LAND USE APPLICATION

PROJECT NO. PRJ19-00008

**FILE NOS. SDP20-00001, MSP20-00001, AAS20-00012,
AAS21-00001, AAS21-00002, AAS21-00005, & AAS20-
00006**

**ISSAQUAH HIGH SCHOOL #4 & ELEMENTARY SCHOOL #17
PROVIDENCE HEIGHTS
4221 228TH AVENUE SE**

Figure 24: Wetland C and Proposed Impacts. Source: ISD (Attachment 38, Page 66 – Critical Area Study & Wetland Mitigation Plan).

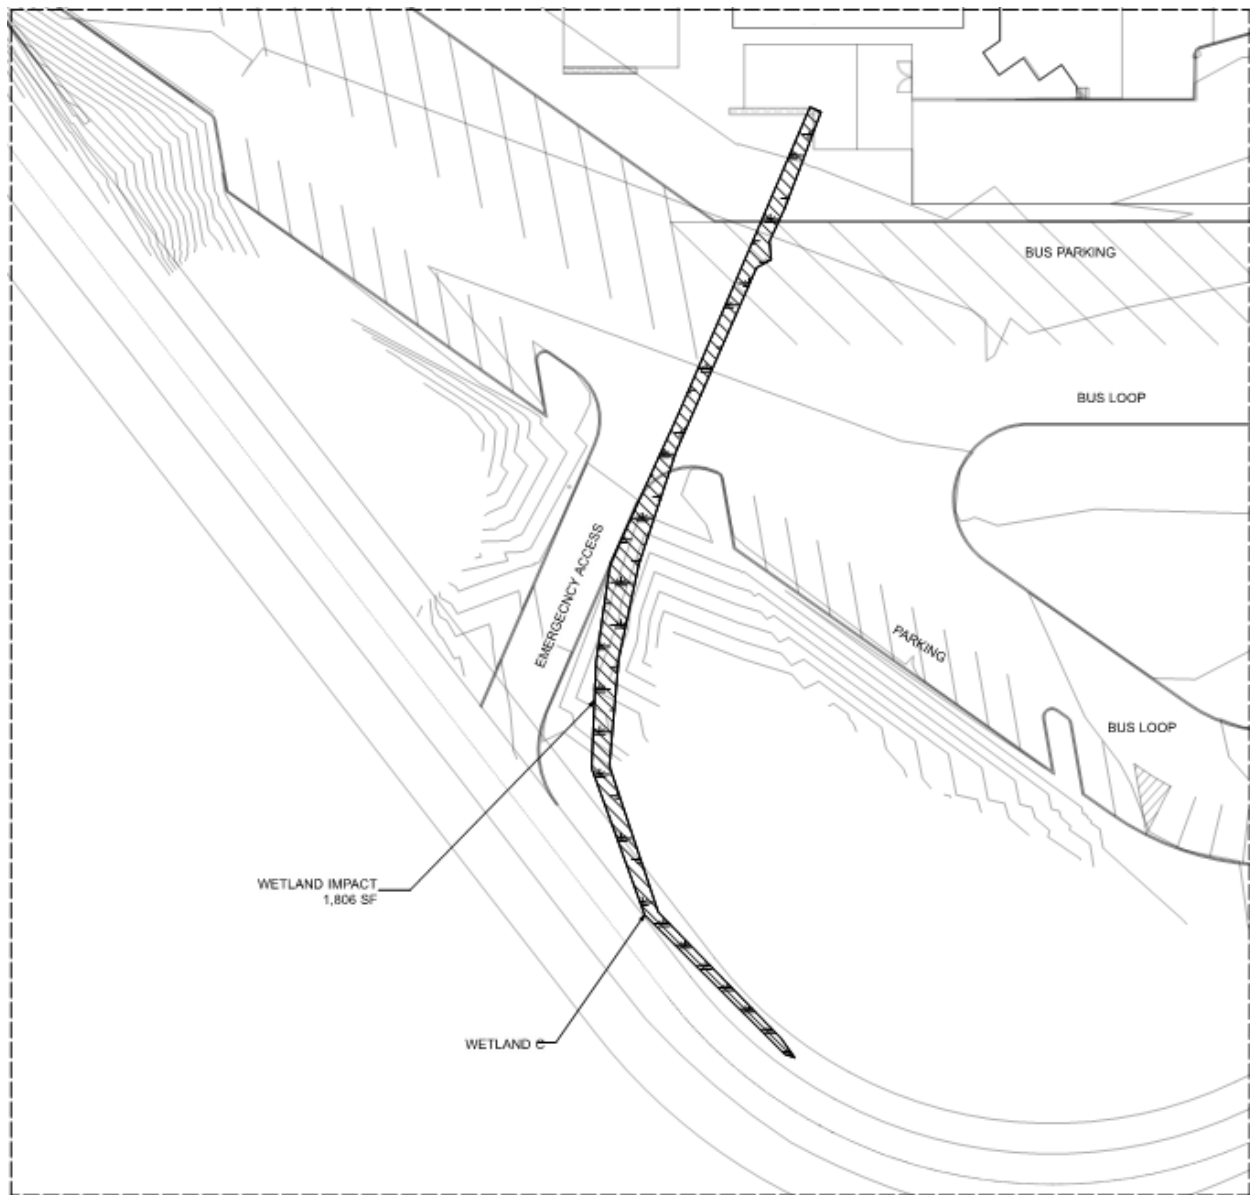
Wetland C is located in the southern portion of the property along an existing paved internal access road that will function as a future emergency access to the site, shown in Figure 24, on the following page. Wetland C is a saturated (non-seasonal) palustrine wetland and is described as a non-persistent emergent wetland (Attachment 38 – Critical Area Study & Wetland Mitigation Plan). The wetland

scored 15 points on the Department of Ecology's Wetland Rating Form for Western Washington, resulting in a Category IV classification per IMC 18.10.620. The wetland scored four (4) points for habitat functions, which is a low habitat value score. The wetland is approximately 1,806 square feet in size. Pursuant to IMC 18.10.640(C), Category IV wetlands less than 2,500 square feet in size do not require a buffer.

The Applicant proposes to impact Wetland C in its entirety by filling it. Impacts will be permanent, and Wetland C cannot be restored. Development activities in wetlands cannot be authorized unless the Applicant has demonstrated that the impact is both unavoidable and necessary. In Category IV wetlands where non-

Figure 25: Area of Concern. Source: ISD (Attachment 38, Page 64 – Critical Area Study & Wetland Mitigation Plan).

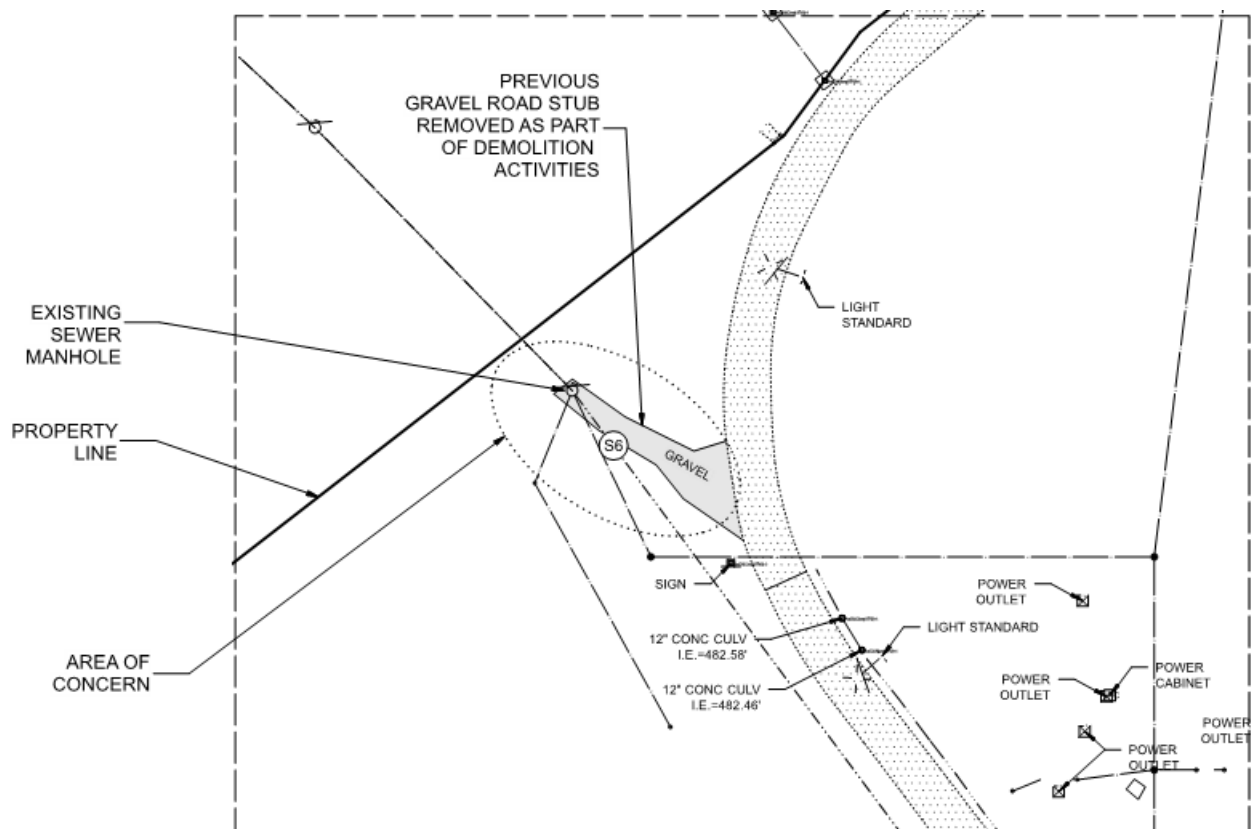
During third-party peer review of the *Critical Area Study & Wetland Mitigation Plan* by Herrera, Inc., a potential wetland area in the northwest portion of the site was identified by standing water and hydrophytic vegetation (see Figure 25, below). Further site investigation by Wetland Resources, Inc. determined that this area of concern is not a wetland.

CONCLUSION: The area of concern is not a wetland. No further investigation is required.

Figure 29: Track and Field Scoreboard. Source: ISD Application Materials (Attachment 98 – Architectural Plans & Building Elevations).

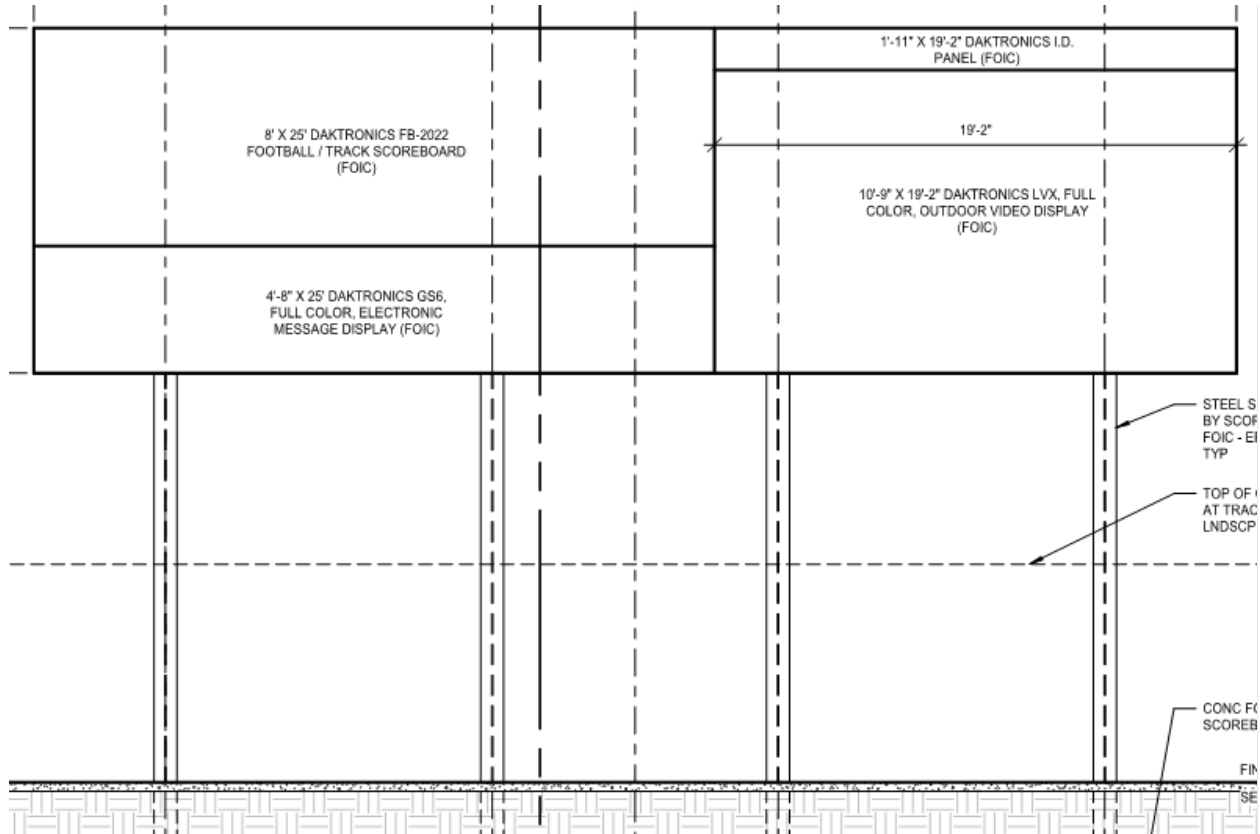
The Applicant is proposing a scoreboard north of the north end of the track, facing southward into the campus (Figure 29, on the following page). The proposed scoreboard will be approximately 27.7 feet high and approximately 44.2 feet wide. The scoreboard will be comprised of four electronic display panels of different sizes for displaying game information. The display area will be approximately 44.2 feet

wide by 12.7 feet high, or 561.3 square feet. The display will be supported by steel posts. The scoreboard is located in the center of the campus and meets applicable setback requirements, is located further than six feet from the principal school buildings, and is located greater than 10 feet from the internal access roadways.
